METROPOLITAN GOVERNMENT OF NASHVILLE AND DAVIDSON COUNTY

Metropolitan Historic Zoning Commission
Sunnyside in Sevier Park
3000 Granny White Pike
Nashville, Tennessee 37204
Telephone: (615) 862-7970
Fax: (615) 862-7974

STAFF RECOMMENDATION
1401 Dallas Avenue
October 17, 2012

Application: Demolition-partial; New construction – addition
District: Belmont-Hillsboro Neighborhood Conservation Zoning Overlay
Council District: 18
Map and Parcel Number: 11801005800
Applicant: Blaine Bonadies, architect
Project Lead: Michelle Taylor, michelle.taylor3@nashville.gov

1401 Dallas Avenue, rear façade. Application includes demolition of screened porch and deck.

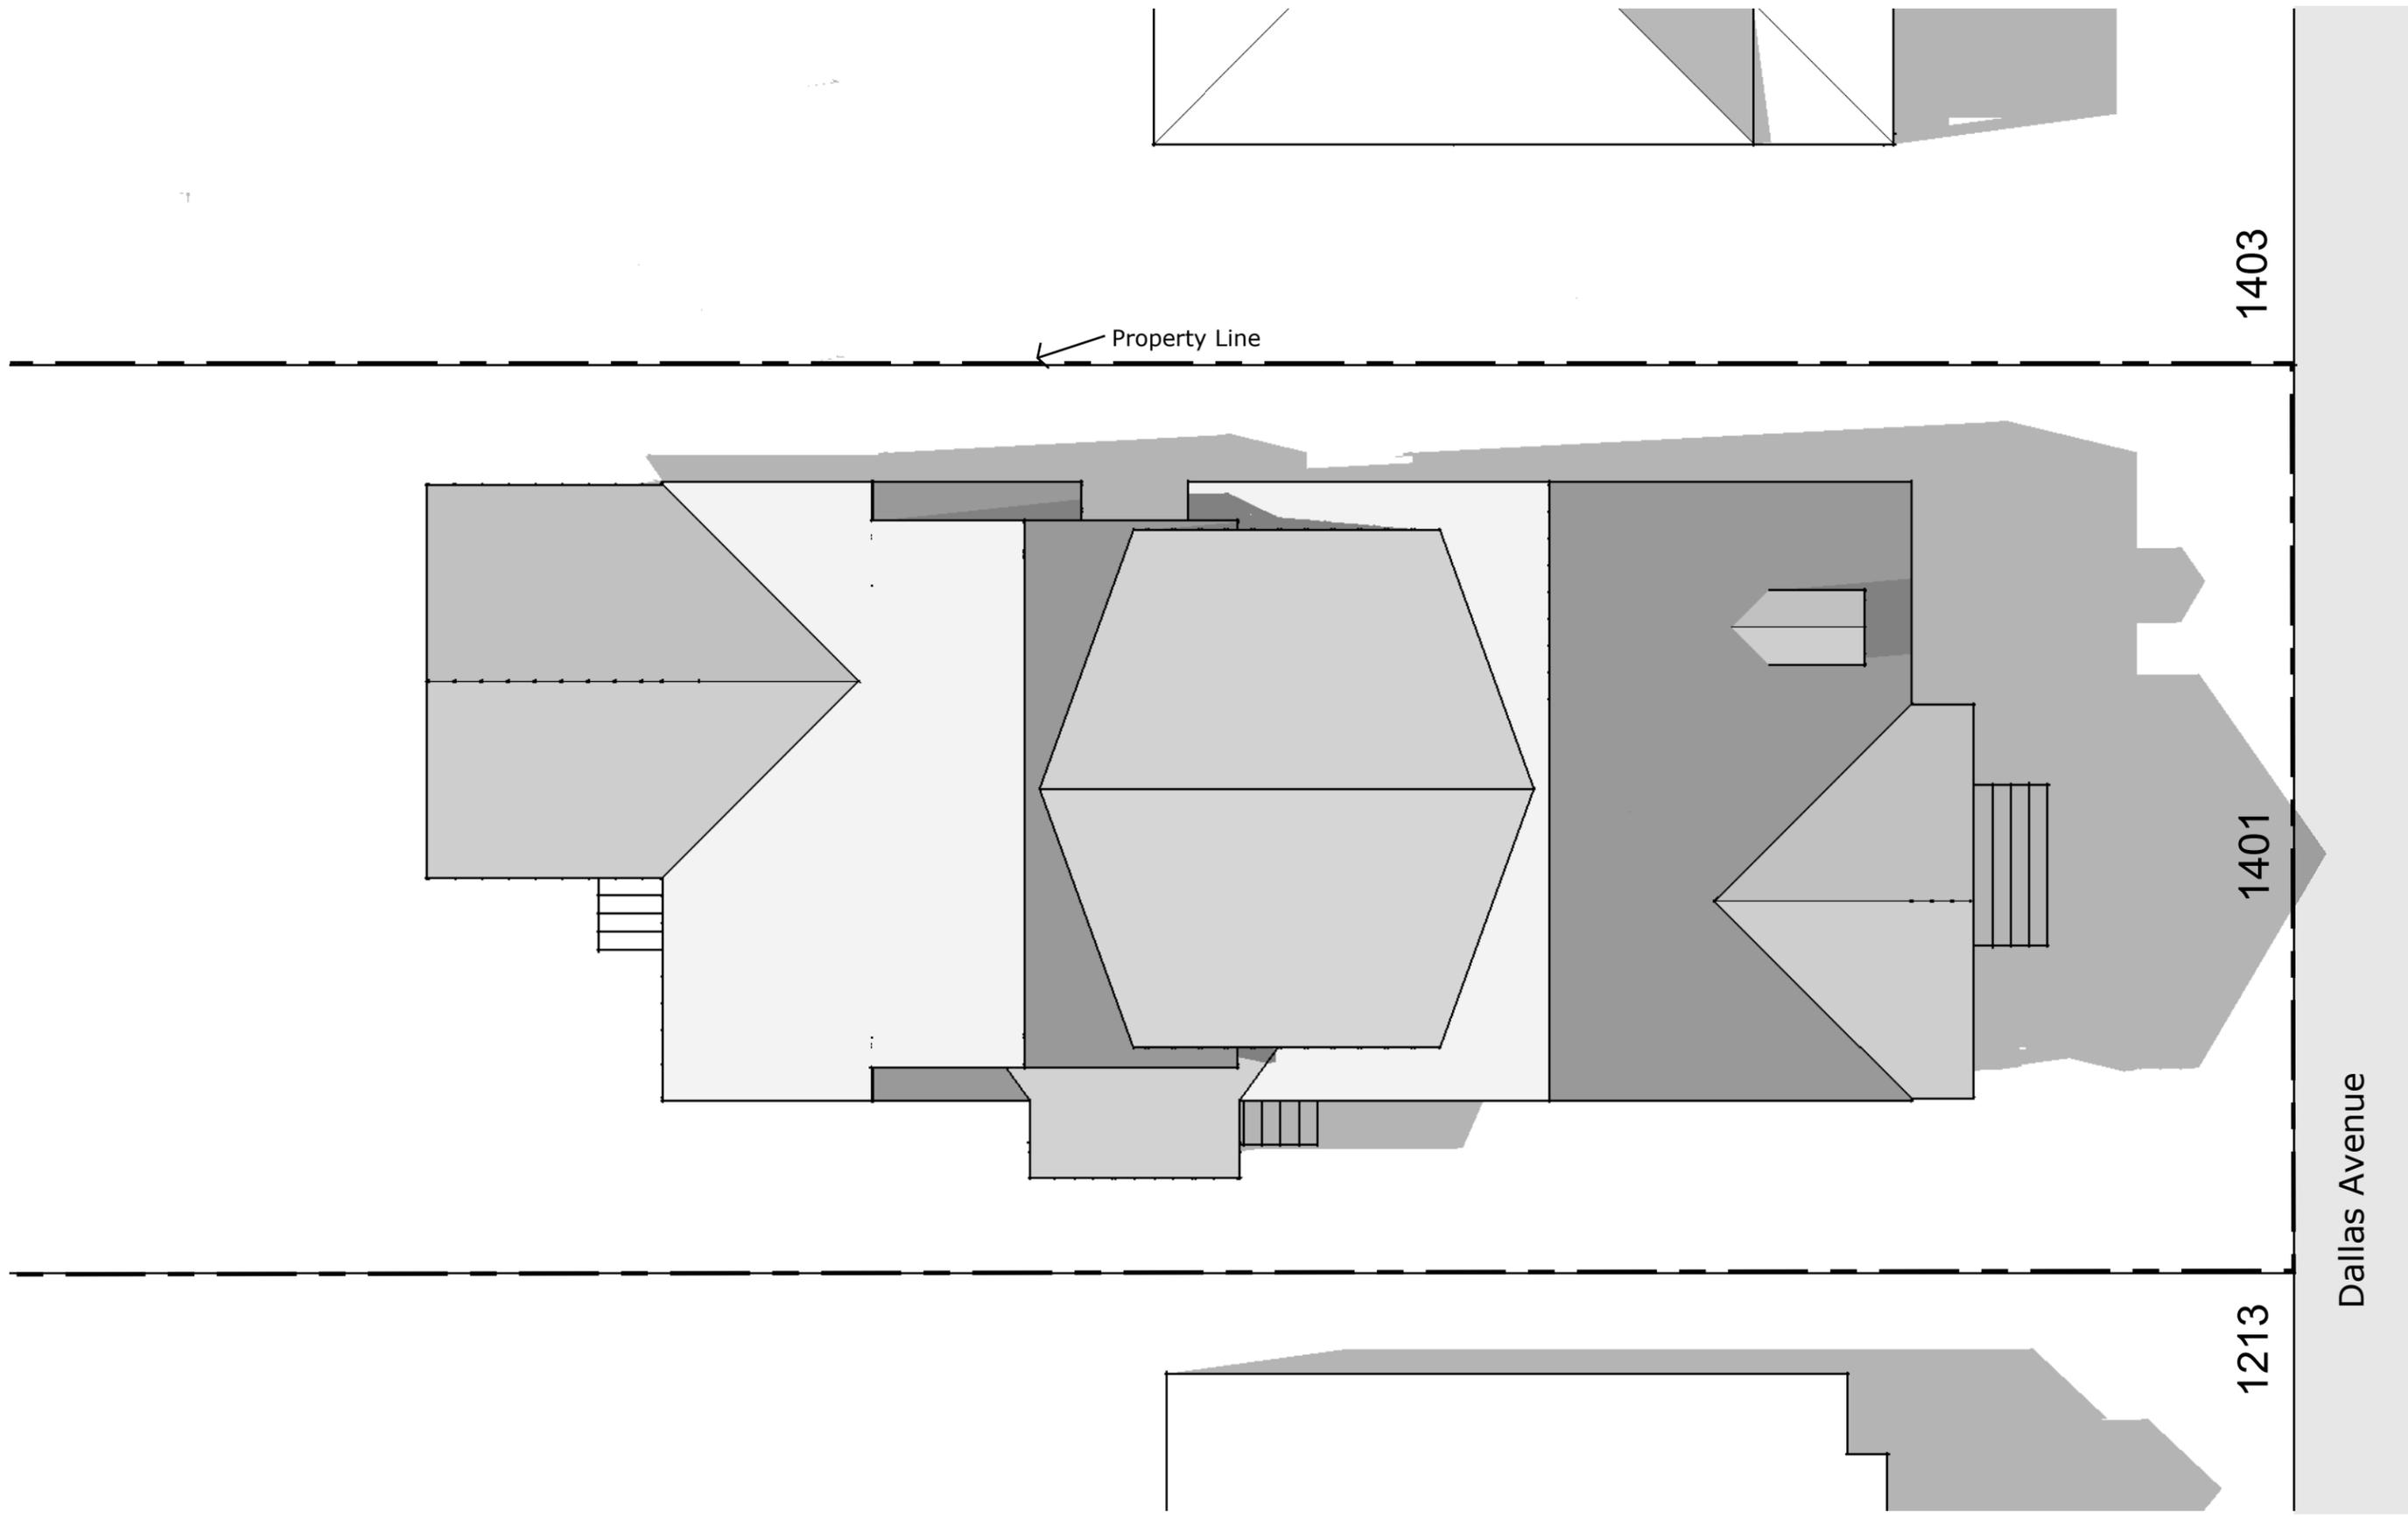
Demolition: There is an existing screened in porch and deck that will be demolished. Neither is historic and so demolition is appropriate and meets section II.B.2.b.

footprint plan

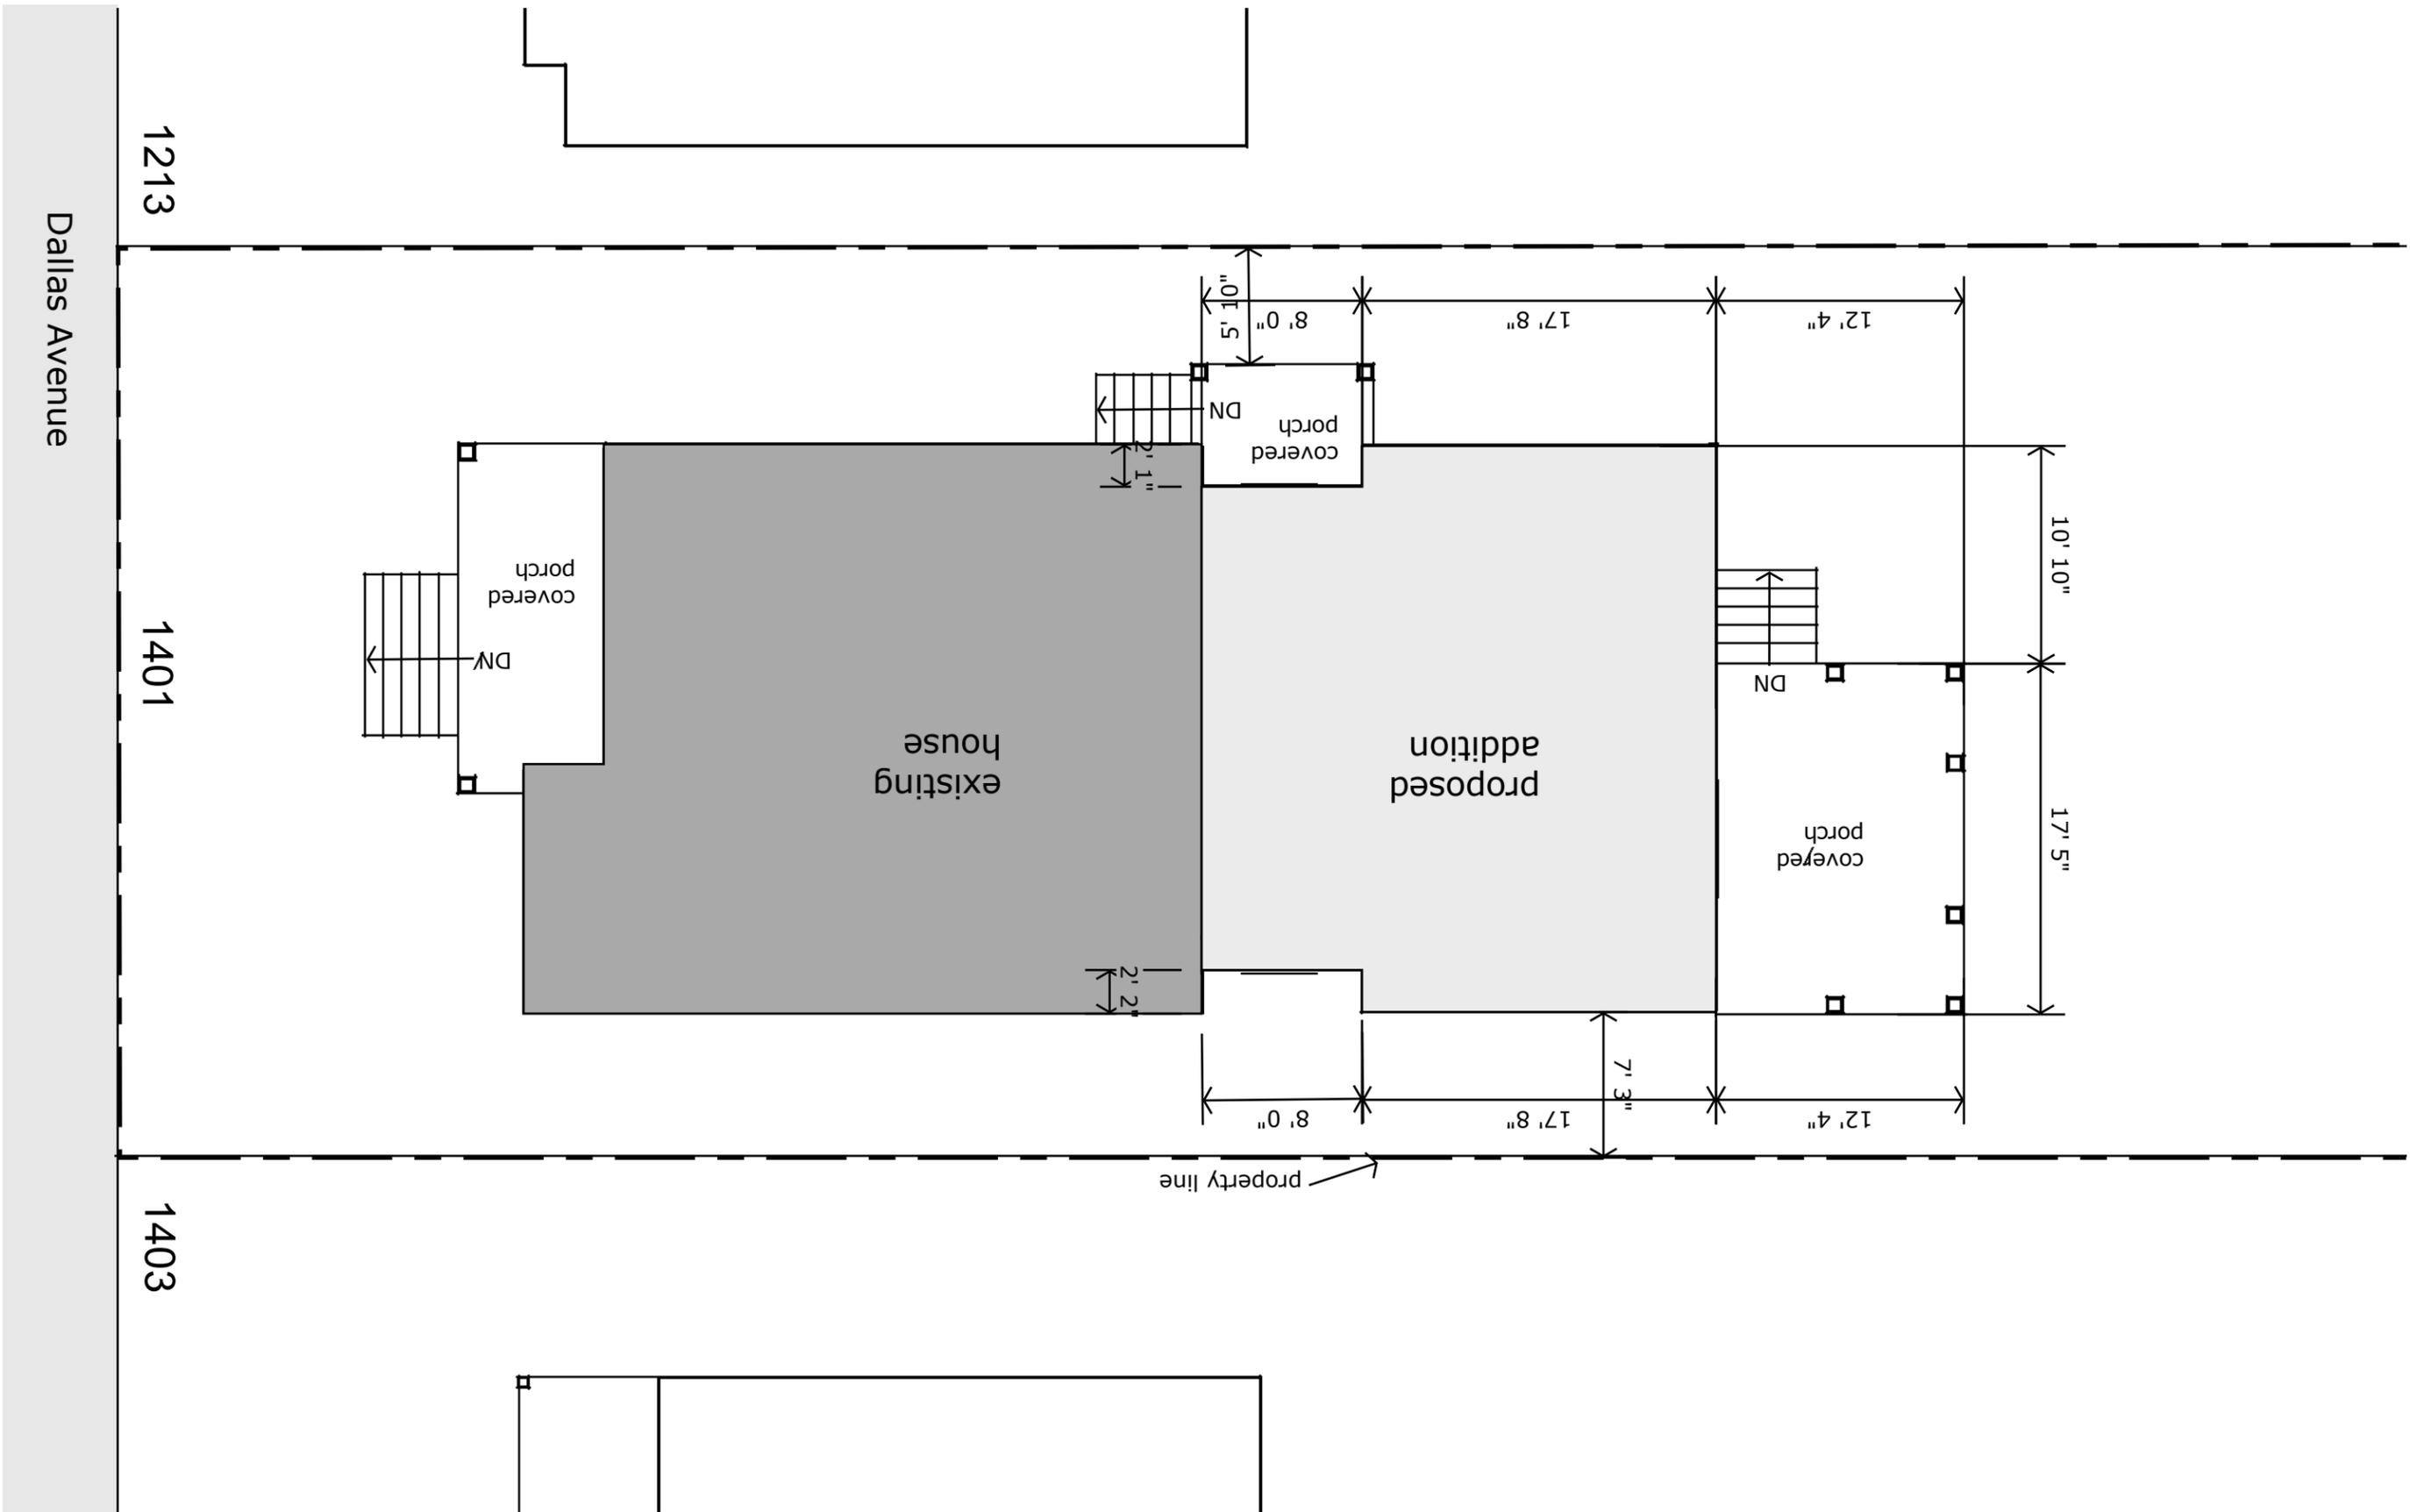
Location and Setback: The addition meets all bulk zoning requirements for setbacks. The right wall of the addition will step in two feet, two inches (2'2") from the historic house, carry back eight feet (8'), and then step back out for another thirty feet (30'). This depth includes a twelve foot, four inch (12'4") rear covered screened porch.

However, the left side of the addition will step out four feet (4') from the rear corner of the historic house, carry back eight feet (8'), before stepping back out in line with the wall of the house for another seventeen feet, eight inches (17'8"). Per the design guidelines an addition should be situated in such a way that will not disturb either the front or side facades and should be distinguishable from the historic structure. Except for specific conditions that this project does not meet, the Commission has always required rear additions inset one foot for each story from the side wall. When an addition needs to be wider than the existing house, it should not wrap the rear corner, as this alters the form of the house and makes it more difficult to remove the addition at a later date, if desired, another condition of the design guidelines. As proposed, the left side of the addition will not inset from the side wall but rather step out four feet (4') from the rear corner. Also, this portion of the addition will be covered and subsequently clip the corner of the existing side-gabled roof.

Because the addition is not inset on the left side which will subsequently compromise the rear corner and form of the house as well as the roof form, is not easily removable, and does not meet the standard developed to keep additions subordinate to primary buildings, staff recommends that the addition have the required one-foot inset.

- The addition sit in a minimum of one foot (1') on each side; and
- Staff provide final review of windows and doors, porch steps and roof color.
